ADDENDUM NO. 2 TO PROJECT NO. 44549

**CONSTRUCTION WORK, HVAC WORK, ELECTRIC WORK
PROVIDE FREEZER & COOLER
BLDG. No.-3 DINING ROOM 1
MID-STATE CORRECTIONAL FACILITY
RIVER ROAD
MARCY, NY**

June 28, 2013

1 PARTIAL FOUNDATION PLAN

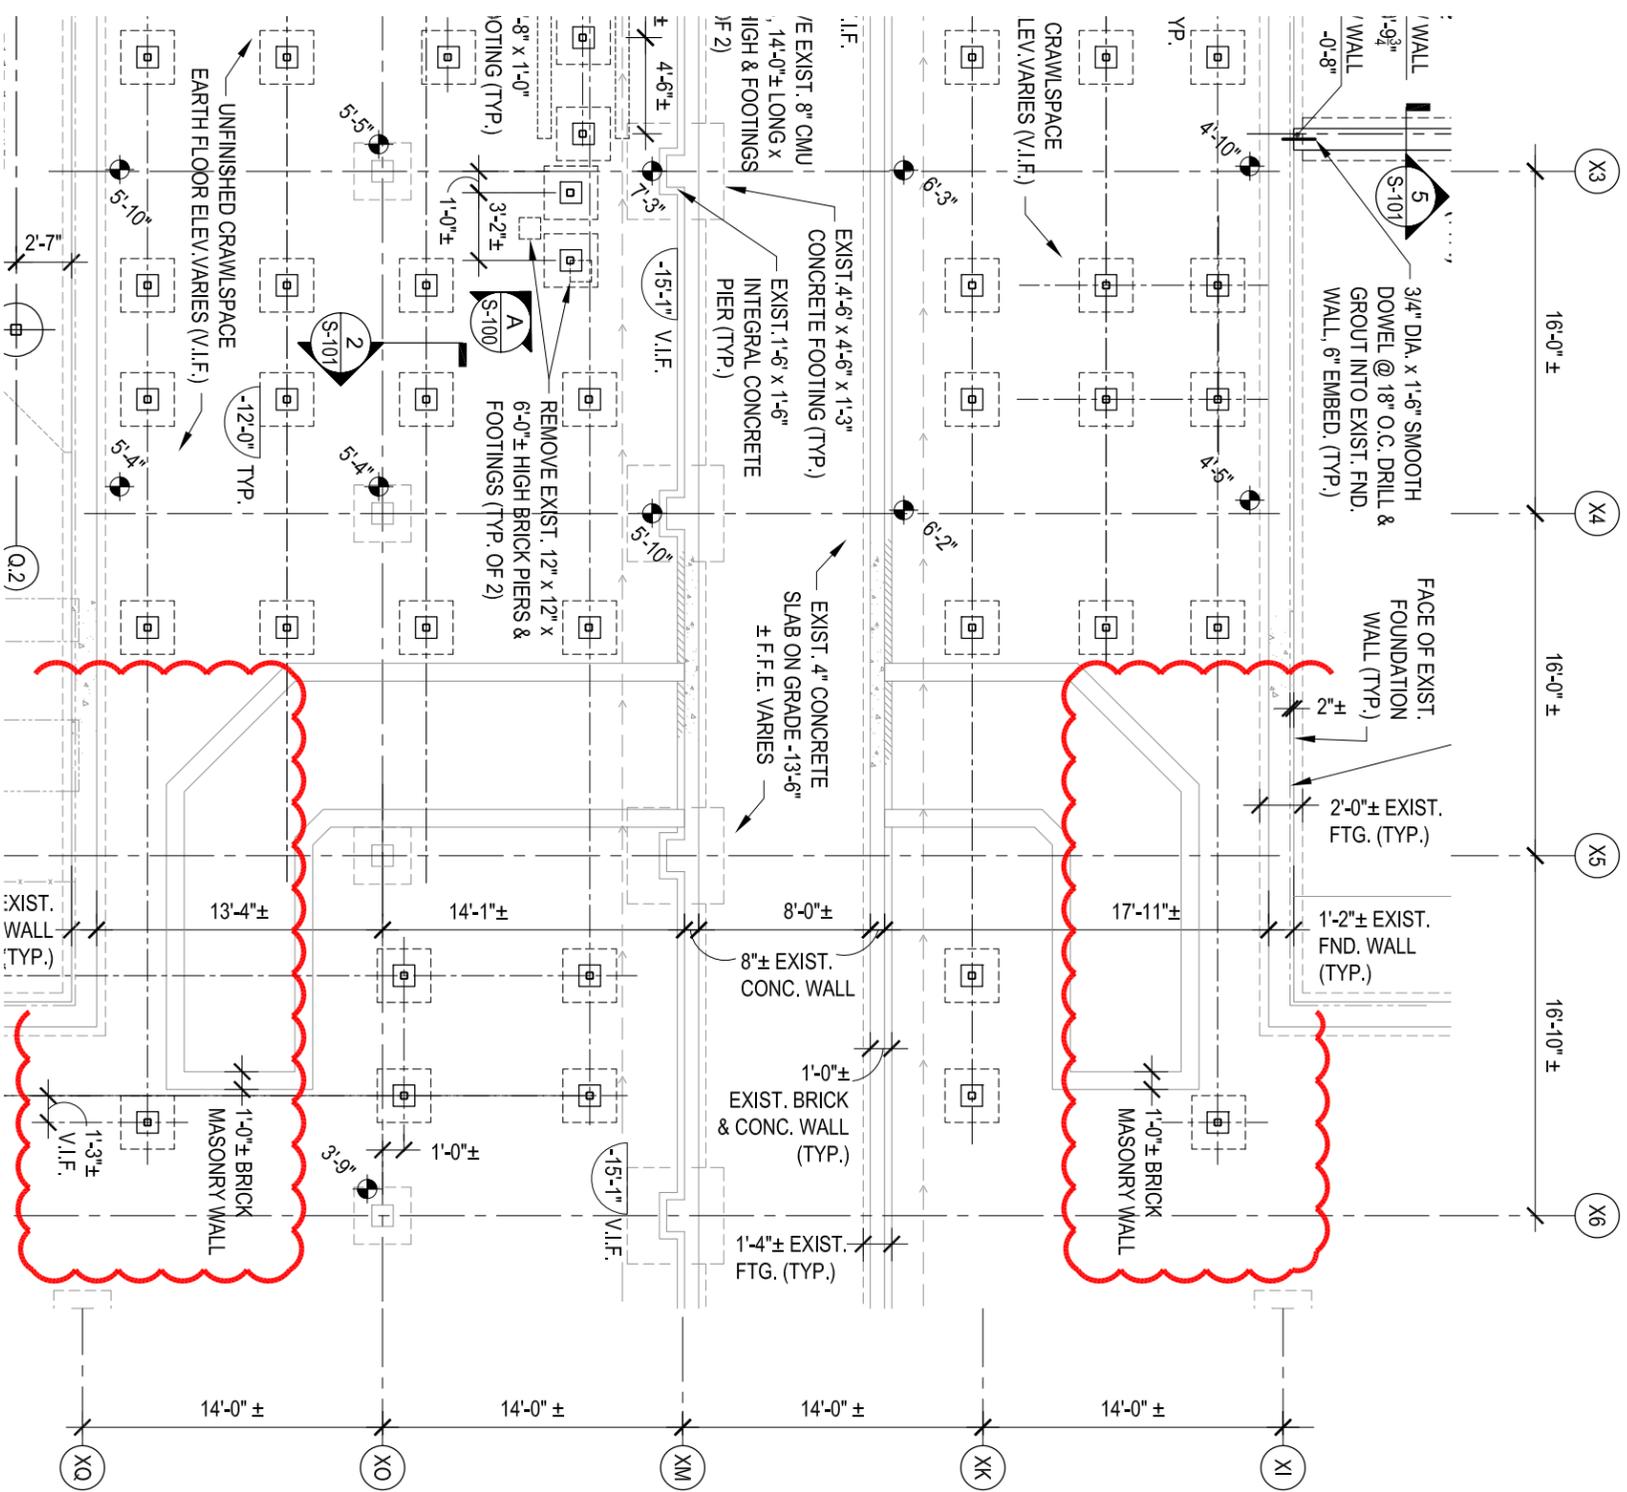
1. REFER TO DRAWING A-102, PARTIAL FLOOR PLANS AND ELEVATIONS, PROPOSED PARTIAL FLOOR PLAN.
 - a. REFER TO LOADING DOCK: Construction Note -19, revise to read 17.
 - b. REFER TO DISHWASHER ROOM 009: Construction Note-19, revise to read Note -17.
 - c. REFER TO CONSTRUCTION NOTES: Delete Construction Note - 19.
2. REFER TO DRAWING S-101 - FLOOR REINFORCEMENT, LOADING DOCK & CANOPY, FOUNDATIONS; PLAN DETAIL 1 – PARTIAL FOUNDATION PLANS FOR FLOOR REINFORCEMENT, DOCK, AND CANOPIES:
 - a. REVISE the Foundation Plan per attached sketch D-01 – Floor Reinforcement; Partial Foundation Plan.

1. WORK THIS SKETCH WITH SKETCH D-02 AND PARTIAL FOUNDATION PLAN ON DRAWING S-101.
2. CONTRACTOR SHALL FIELD VERIFY SIZE AND LOCATION OF EXISTING CRAWLSPACE PIPING PRIOR TO PREPARATION OF SHOP DRAWINGS AND NOTIFY THE DIRECTOR'S REPRESENTATIVE OF DISCREPANCIES.

1 PARTIAL FIRST FLOOR FRAMING PLAN

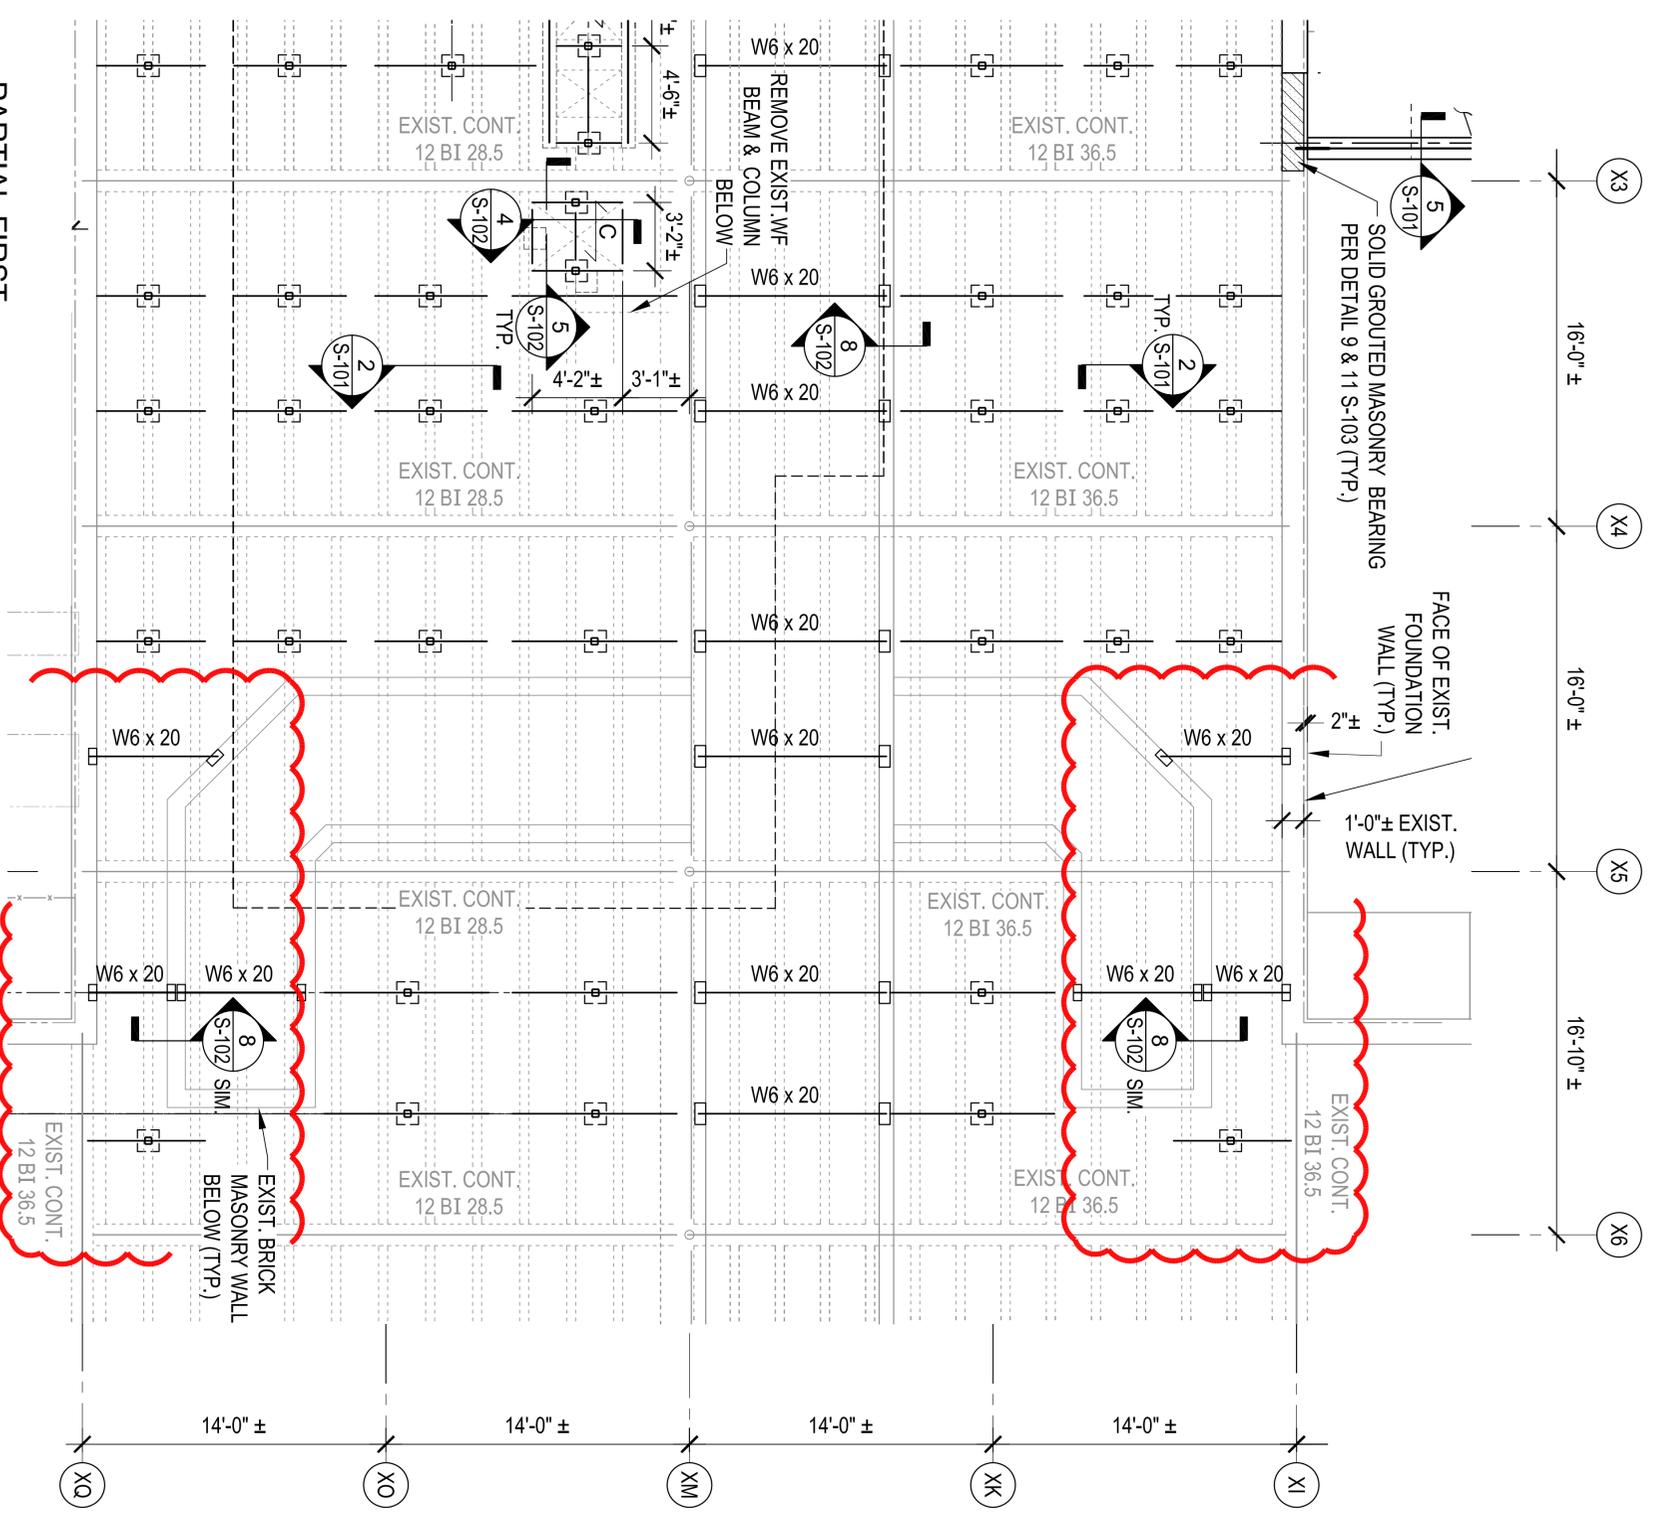
3. REFER TO DRAWING S-102 - FLOOR REINFORCEMENT, LOADING DOCK & CANOPIES, FRAMING PLANS & DETAILS; PLAN DETAIL 1 – PARTIAL FIRST FLOOR FRAMING PLAN, FLOOR REINFORCEMENT AND DOCK:
 - a. REVISE the First Floor Framing Plan per attached sketch D-02 – Floor Reinforcement; Partial First Floor Framing Plan.

- NOTES:
 1/8" = 1'-0"
1. WORK THIS SKETCH WITH SKETCH D-01 AND PARTIAL FIRST FLOOR FRAMING PLAN ON DRAWING S-102.
 2. CONTRACTOR SHALL FIELD VERIFY SIZE AND LOCATION OF EXISTING CRAWL SPACE PIPING PRIOR TO PREPARATION OF SHOP DRAWINGS AND NOTIFY THE DIRECTOR'S REPRESENTATIVE OF DISCREPANCIES.
